PROPOSAL:
New: Hotel (157 Units), Multi-Residential Development (44 Units), Restaurant: Licensed – Medium, Restaurant: Food Service Only – Small, Retail Store.

APPLICANT: Clem Lau Architects and Designers	OWNER: You Lee Holding Company Ltd.
MUNICIPAL ADDRESS: 1227 MacLeod Trail SE and 234 - 13 Avenue SE	LEGAL DESCRIPTION: Plan C; Block 89; Lots 21 to 24 (Map 15C)
EXISTING LAND USE DISTRICT(S): Centre City Mixed Use District	
AREA OF SITE: 0.13 ha ± (0.32 ac ±)	
CURRENT DEVELOPMENT: 2 storey commercial development, and 2 storey single detached residential development

CORPORATE PLANNING APPLICATIONS GROUP RECOMMENDATION: REFUSAL

DP2009-3829

1 SITE PLAN
SCALE 1:100

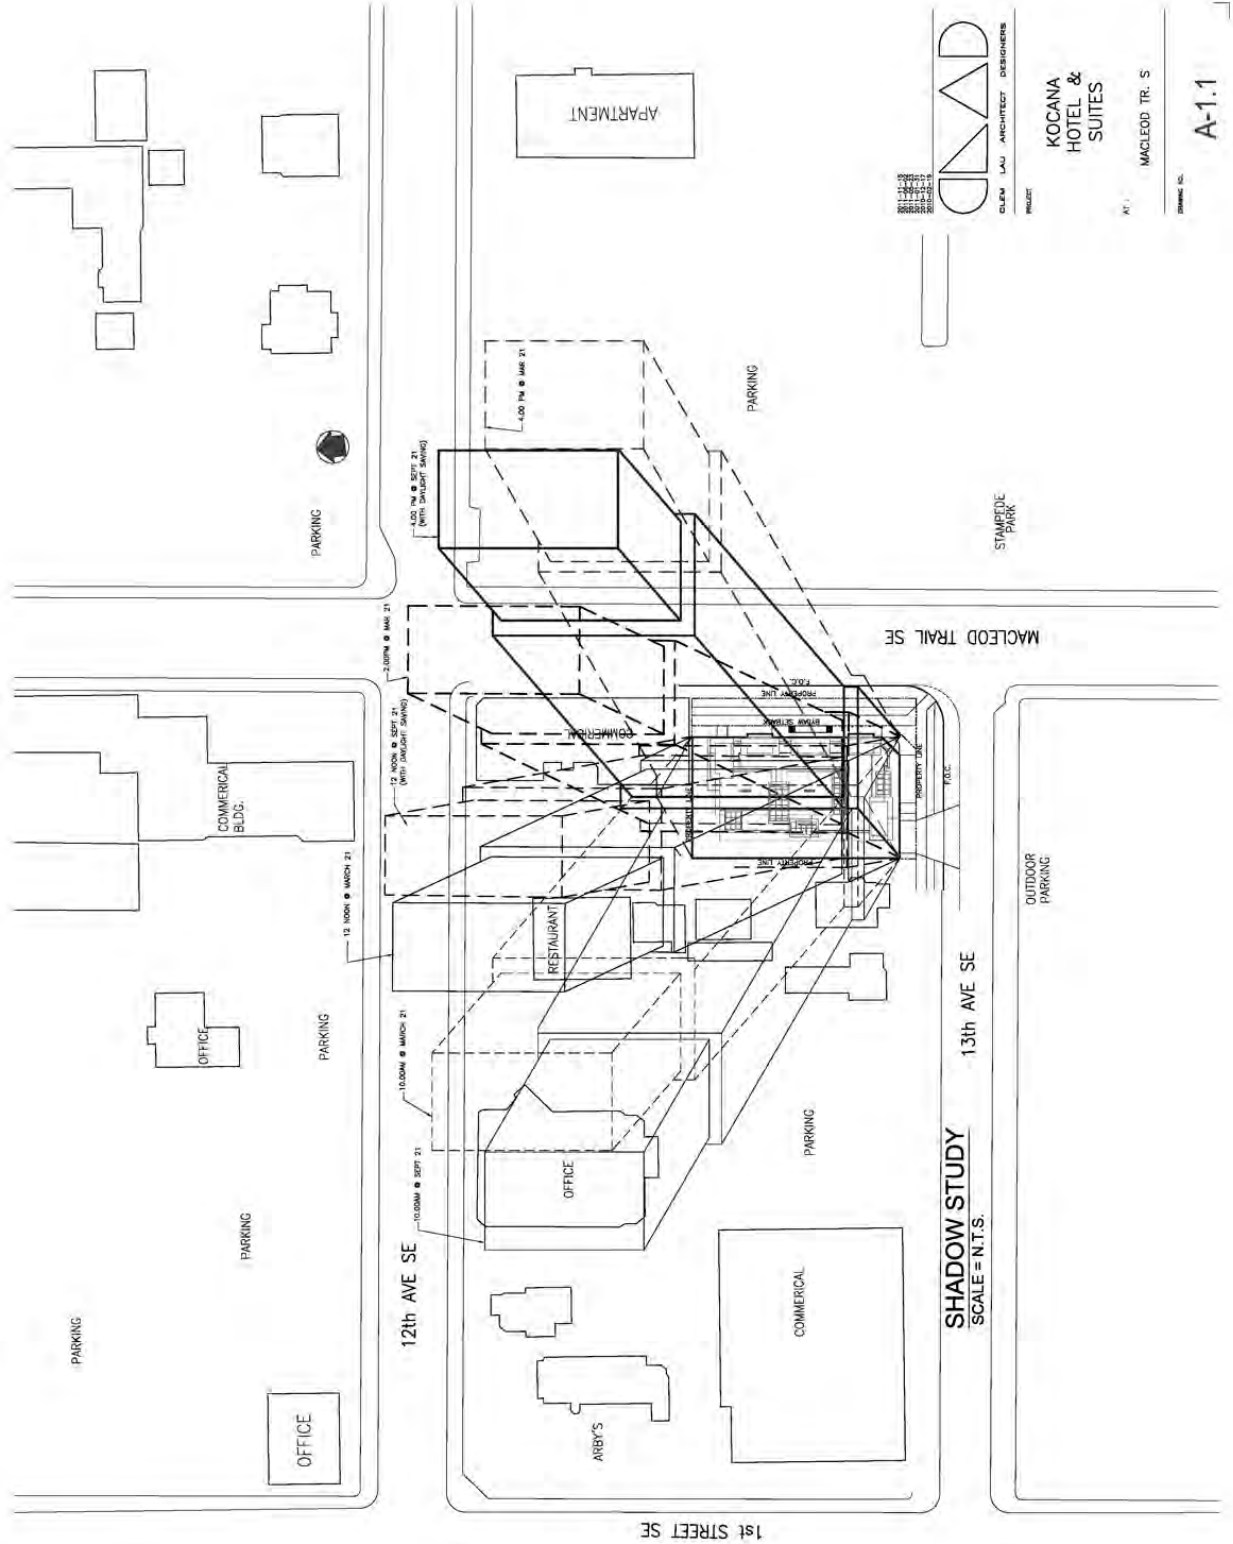
No landscaping has been proposed at grade in an attempt to integrate the private realm with the public realm of the 13 Avenue Greenway and MacLeod Trail Urban Boulevard treatments. Additionally, the overall condition of driveway and associated curb-cut access to 13 Avenue SE does not respect the Greenway policies which call for pedestrian and cyclist priority. Additional opportunities have been missed in the location of amenity spaces for the project, as any such at grade spaces lack uses which would activate the transition edge. Administration finds the following Beltline ARP objectives have not been achieved within the proposed development:

- The recommendation of a hard landscaping treatment adjacent to MacLeod Trail SE due to high traffic volume, and the likelihood of plant materials deteriorating due to gravel, salt, etc.
- The support for a +15 style connection spanning MacLeod Trail SE connecting the hotel to the Stampede grounds.
- A recommendation for the incorporation of a lay-by within the existing pedestrian right-of-way adjacent to MacLeod Trail SE to allow for ease of taxi, visitor, and resident drop-off.

- While the design for this portion of MacLeod Trail SE has yet to be confirmed, fescue grass mix and/or native fruiting shrub understory is to be implemented adjacent to roadways along 13 Avenue SE, and this condition is likely to be mirrored for MacLeod Trail SE.
- While the applicant contemplated the proposal of a +15 type connector westward to the Stampede grounds at the pre-application stage of this review, it should be noted that the this site is located outside of the downtown boundaries where +15 connections are supported, in addition to having a land use which would not provide for additional bonusing density for the construction of a bridge.

1 VEHICLE SWEEP PATH
 A.1.2 / SCALE = 1:150
 (FROM STREET LEVEL DOWN TO PICK-UP)

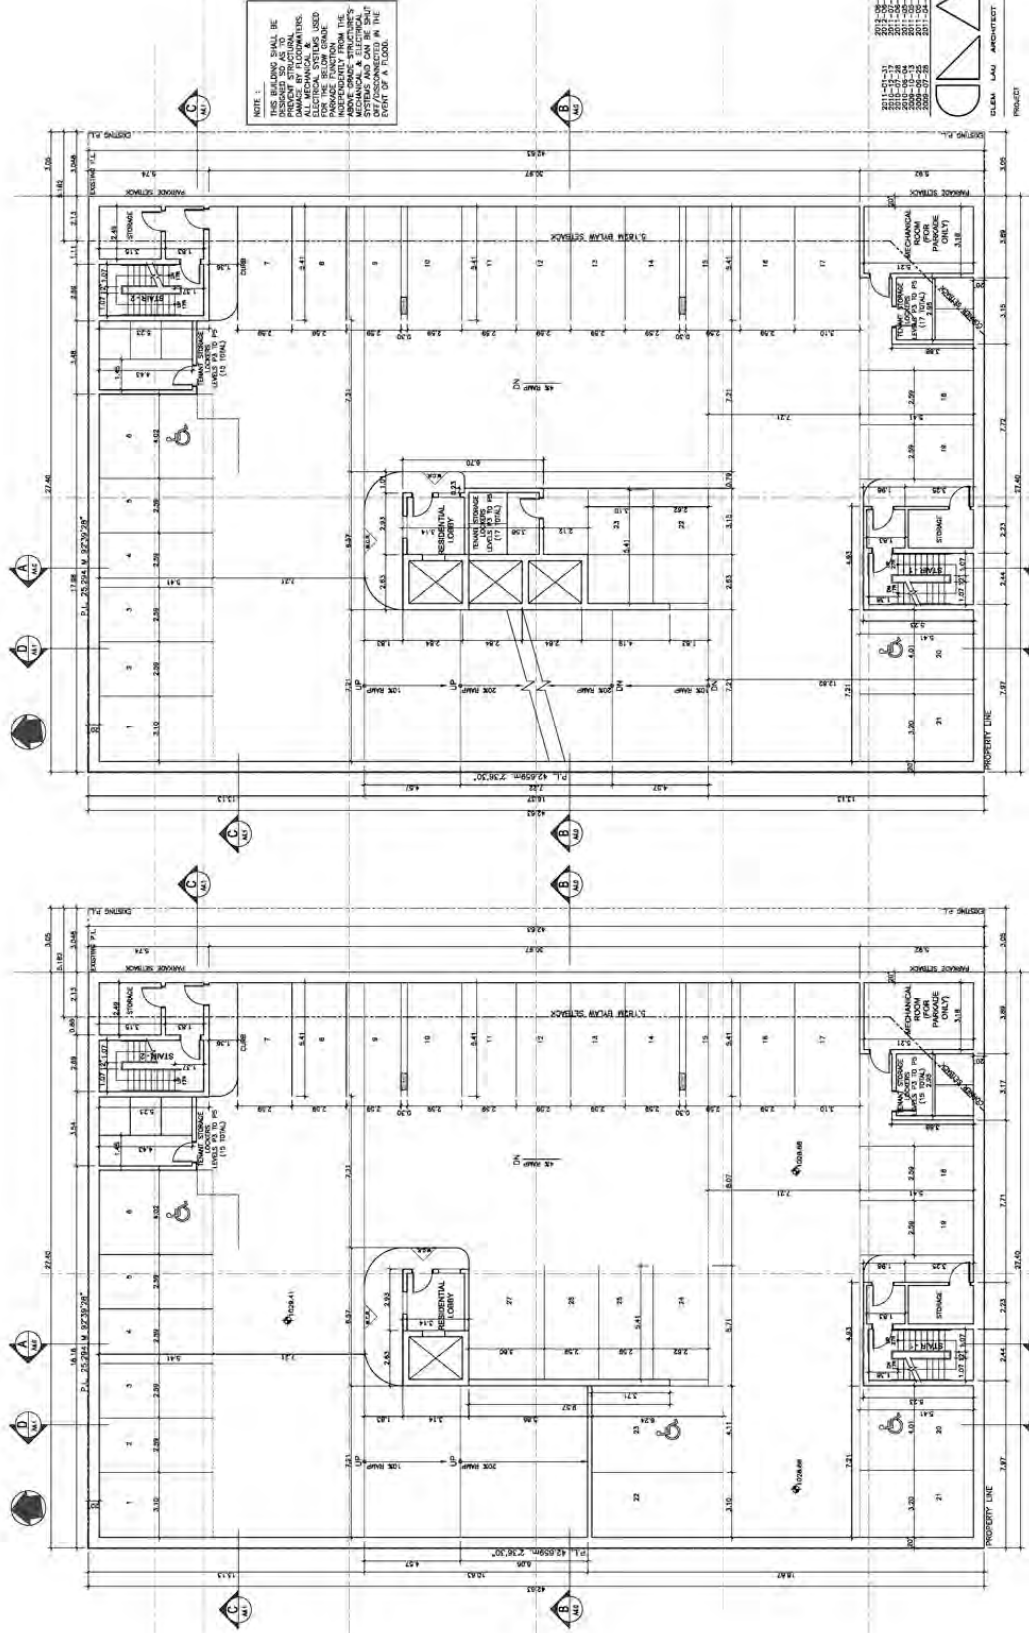
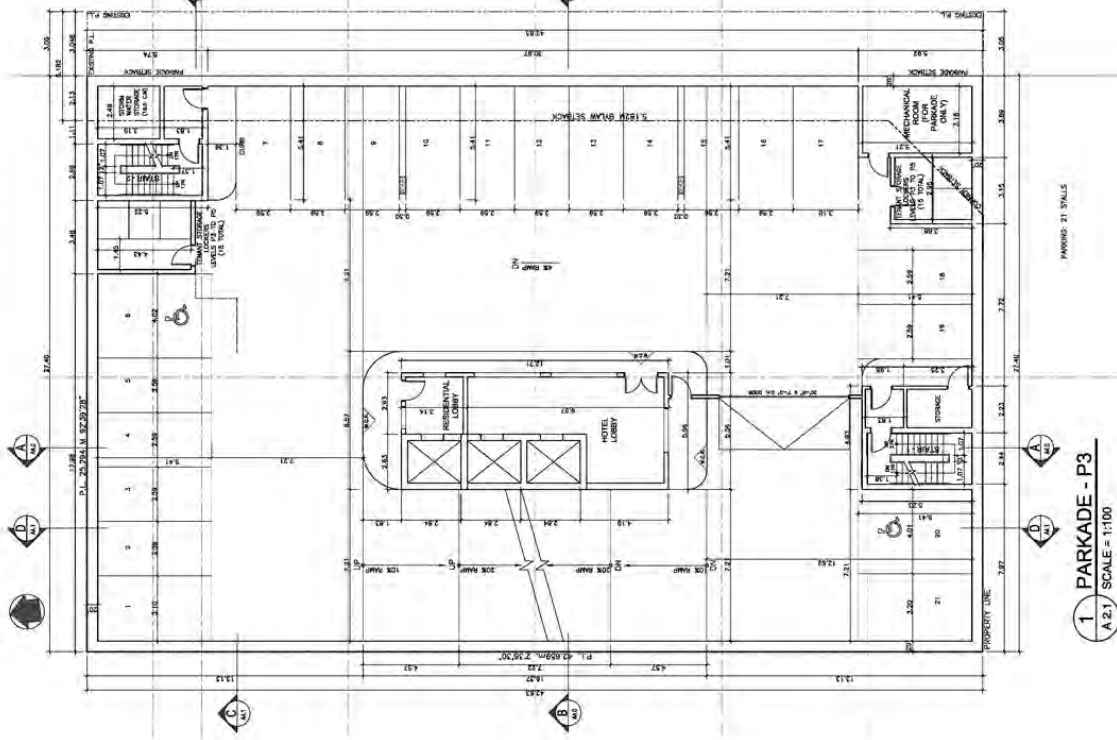
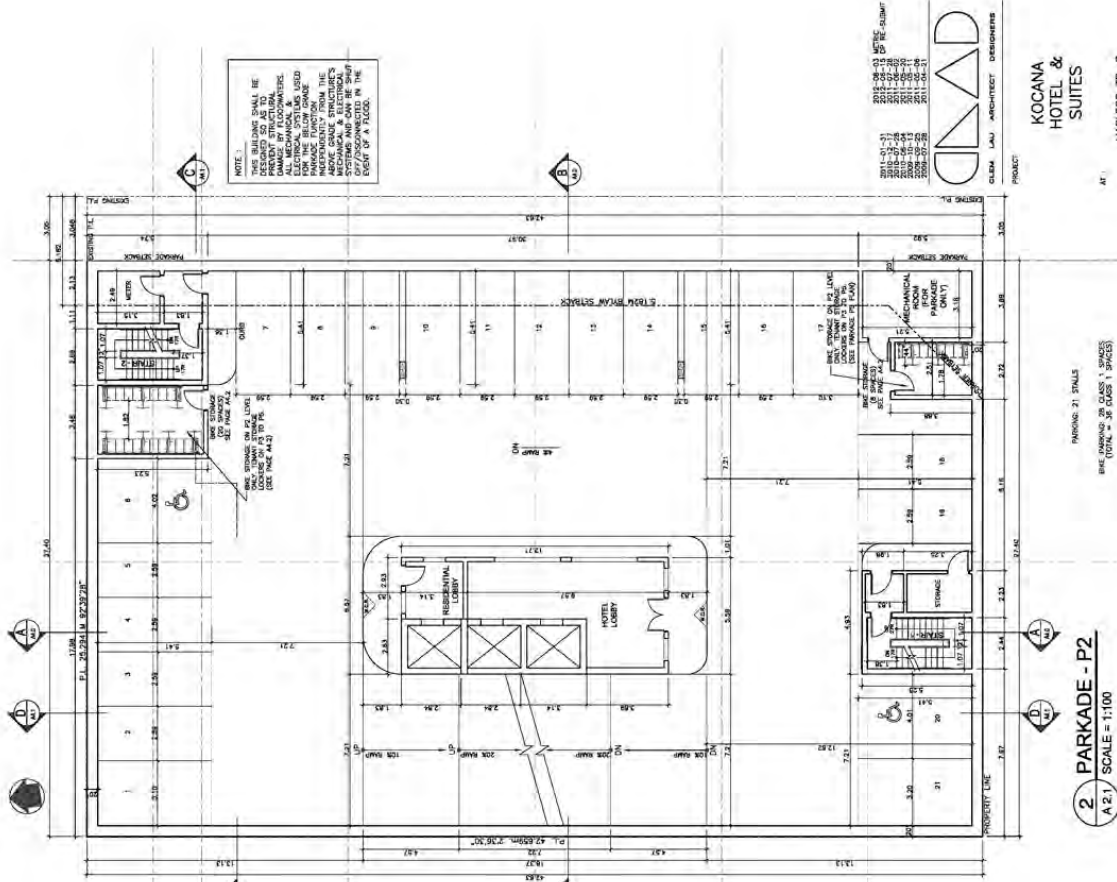
Due to heavy traffic volumes on the northbound MacLeod Trail SE, vehicular access is restricted along this roadway. As no rear lane exists on the site, residential guests, hotel guests, loading, waste and recycling, as well as taxi drop off locations to access the property are confined to a single driveway in the southwest corner of the property adjacent to 13 Avenue SE. Given the relatively narrow lot configuration, a turning disk was required within the loading bay to allow for City Standard vehicles to exit the site without reversing extended distances.

Given the absence of a lay-by area on the site, transportation has agreed to allowing the hotel operator to purchase movable signage which will denote a section of curb on the south side of 13 Avenue SE as a 'No Parking Temporary Loading Zone'. Prior to the arrival of a tour bus, the hotel operator would place the signage in this location to allow the bus to stop and unload visitors prior to leaving the site and parking in an alternate location. Visitors would cross 13 Avenue at the corner of MacLeod Tr. SE, and access the hotel via the corner entry doors.

TOUR BUS LOADING IS
 TEMPORARY "NO PARKING"
 TO BE PURCHASED FROM
 TRANSPORTATION AND TO
 ADVISE TRANSPORTATION DEPT.
 THE TIME AND DAY OF LOADING
 FOR THE BUS REQ'D.

1 PARKADE - P1
SCALE = 1:100

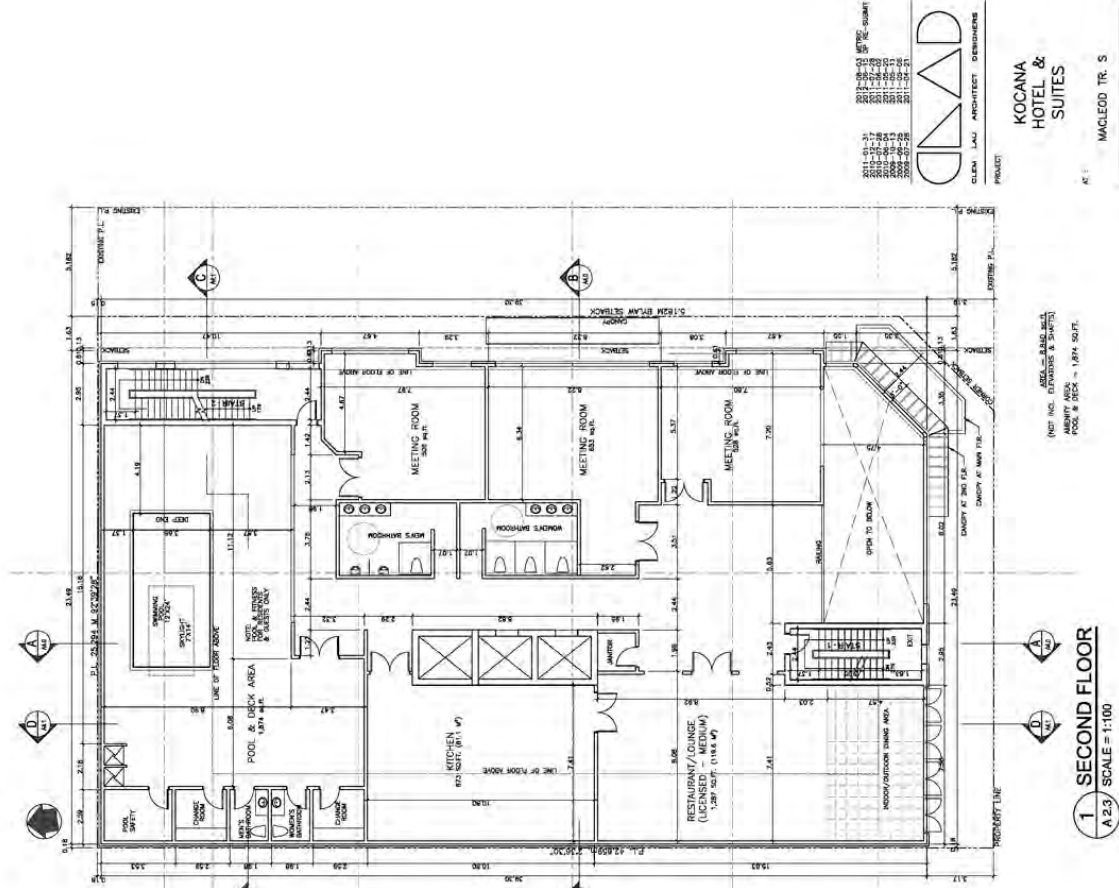
As highlighted by the Urban Design Review Panel, Administration finds the P1 level should be considered as part of the public realm given the lack of drop-off or lay-by facilities at grade. As such, all visitors to the site who are travelling by taxi or by personal vehicle will be welcomed to the site within the underground parking structure.

Upon arriving at the site, visitors would utilize the speaker box adjacent to the driveway to gain entry to the parkade. The first level of the parking structure contains a loading/waste and recycling area, passenger loading area, 7 visitor parking stalls, in addition to separate residential and hotel elevator lobbies. Keycard access will be required for residential floors, while hotel visitors can gain entry to the main floor of the development without access card, to allow visitors to check-in. Raised sidewalks have been provided linking stairwells to the central elevator lobbies on this level to emphasize its pedestrian priority. Upon descending further into the parkade and overhead garage door has been proposed within the P3 level of the structure which would delineate between hotel parking on the upper floors, and secured residential parking on lower levels. Bicycle parking has been provided in 2 locations on the P2 level, and in a single location in the southeast corner of the project on the P1 level.

Administration finds that a substantial amount of direction/instructional signage would be required both on the exterior of the building in addition to throughout the parking levels in order to ensure users understand this intended operation. No signage has been included within the proposed application.

In discussing this development permit, it was noted that a lay-by was not included for the hotel. This discrepancy has been addressed by using the first level of underground parking. BPG finds this creative solution acceptable.

WEST ELEVATION
SCALE = 1/8" = 1'-0"

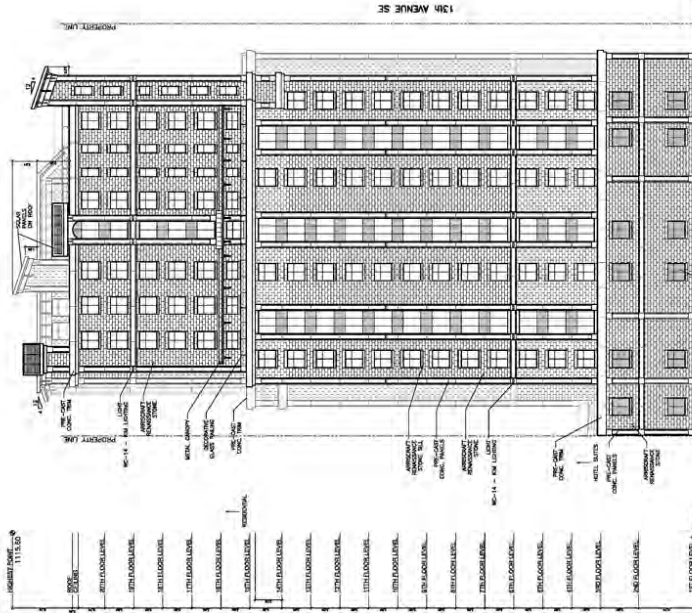
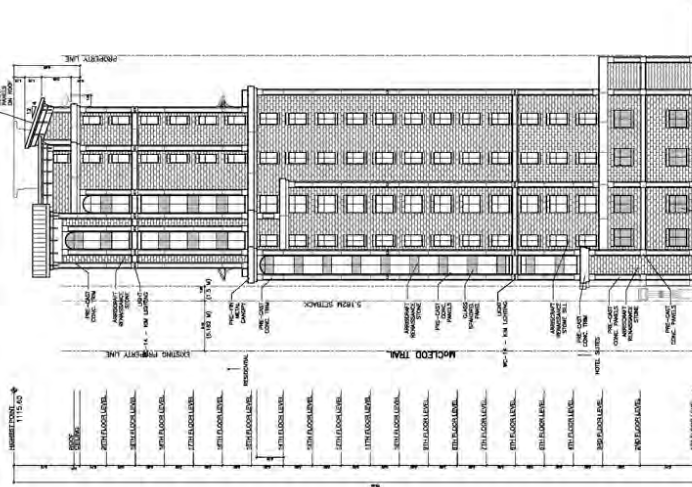
The proposed development fails to provide the types of interesting, engaging, and active façades at grade level, identified in sections of the Beltline ARP as below. The 13 Avenue SE façade incorporates functional uses inclusive of two overhead doors providing access to the parkade and loading area respectively, as well as a fire exit stairwell. This elevation is of particular importance, due not only to the 13 Avenue Greenway Policy, but also because of its high visibility to northbound only traffic on MacLeod Trail SE. While the MacLeod Trail frontage incorporates modestly higher amounts of visual permeability, the proposal still lacks a significant active use at grade level, which would work towards activating this façade. Active uses such as restaurant and gift shop, which were previously present at grade, are now relegated to the second floor, or eliminated from the proposal entirely. Administration finds the following Beltline ARP objectives have not been met within the proposed development:

The Beltline ARP encourages high standards of design at grade on street and avenue frontages. Administration finds the subject application fails to provide an innovative and aesthetically appropriate solution to the vehicle access and egress issues inherent within this site given the lack of rear lane, and its frontage on the heavily trafficked MacLeod Trail SE. The lack of pedestrian access points along the southern frontage is contrary to the ‘pedestrian first’ policies of City planning policies, effectively dedicating the eastern-most stretch of the 13 Avenue Greenway for vehicular functions. Hence, Administration finds the applicable Beltline ARP objectives have not been achieved within the proposed development and further comprises the goals of the ARP’s vision of a pedestrian oriented greenway along 13 Avenue S.
